Regular Meeting Agenda
September 13, 2021 – 7:00 P.M.

CHANGE ORDER

OWNER Village of Roscommon
 CONTRACTOR Sterling Excavation, Inc.
 Contract: Contract 1 Collection System Repairs
 Project: USDA Wastewater System Improvements
 OWNER's Contract No. 838942-1 ENGINEER's Project No. 838942-1
 ENGINEER Fleis & VandenBrink

BULLETIN NO. 2

Enclos.: Sheet C8

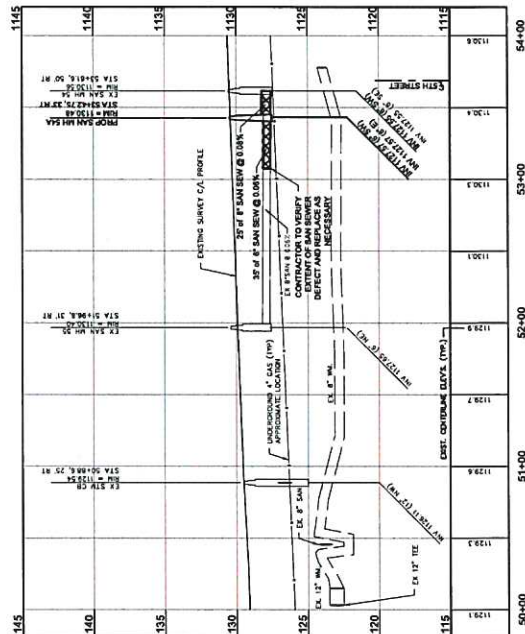
Upon additional sewer televising and exploration of the collection system, a segment of sewer main appears to be collapsed. The area is unable to be repaired by a trenchless method. Removal and replacement of the collapsed sewer is proposed on Lake Street near the intersection with Fifth Street. The sewer installation is shown on drawing C8 enclosed herein. The alignment of the existing sewer is also curved horizontally and to correct this issue a new manhole structure is proposed to straighten the alignment.

The proposed work is within the MDOT Right of Way and involves additional contractor coordination and protection of existing electrical utilities for traffic and pedestrian signals. An MDOT Right of Way permit and amended EGLE Part 41 permit will be obtained by F&V. The estimated quantities related to the installation are provided in the following table:

Other unit rate items that are affected shall be paid for by the actual units installed. For instance, if additional pavement removal and HMA placement is necessary, the cost will be reflected by the actual quantity of those unit rate items. The add/(deduct) of this bulletin should not include the cost of unit rates previously established. A table of quantities with adjusted units is provided on the following page.

Enclos.: Sheet C8

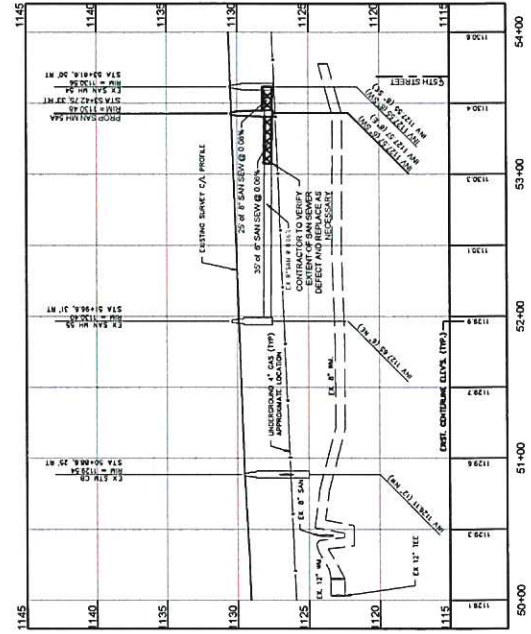
Upon additional sewer televising and exploration of the collection system, a segment of sewer main appears to be collapsed. The area is unable to be repaired by a trenchless method. Removal and replacement of the collapsed sewer is proposed on Lake Street near the intersection with Fifth Street. The sewer installation is shown on drawing C8 enclosed herein. The alignment of the existing sewer is also curved horizontally and to correct this issue a new manhole structure is proposed to straighten the alignment.

Other unit rate items that are affected shall be paid for by the actual units installed. For instance, if additional pavement removal and HMA placement is necessary, the cost will be reflected by the actual quantity of those unit rate items. The add/(deduct) of this bulletin should not include the cost of unit rates previously established. A table of quantities with adjusted units is provided on the following page.

C11 SKETCH ADDITIONAL TREE REMOVAL

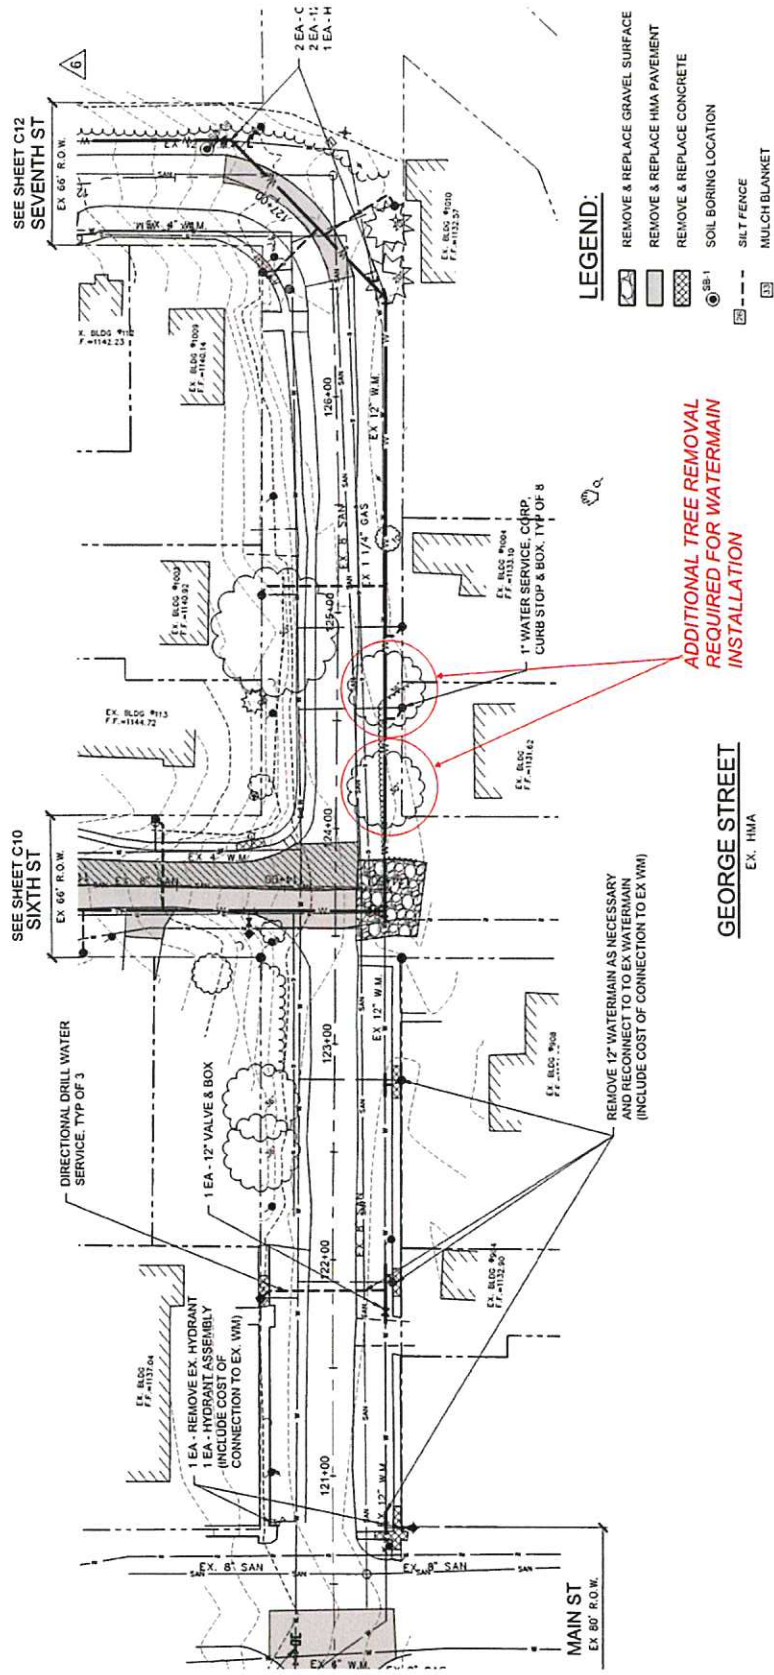
Two large trees (>30" in diameter) are required to be removed as part of the 12-inch watermain installation on George Street authorized by a change order. See Bulletin No. 1 and Change Order No. 2 for more details. The two large trees are also located near to overhead electrical utilities and were not originally included in the bid (Line Item No. 7) due to changes set forth in Change Order No. 2.

Total Item No. 1 - Add \$ 3500.00
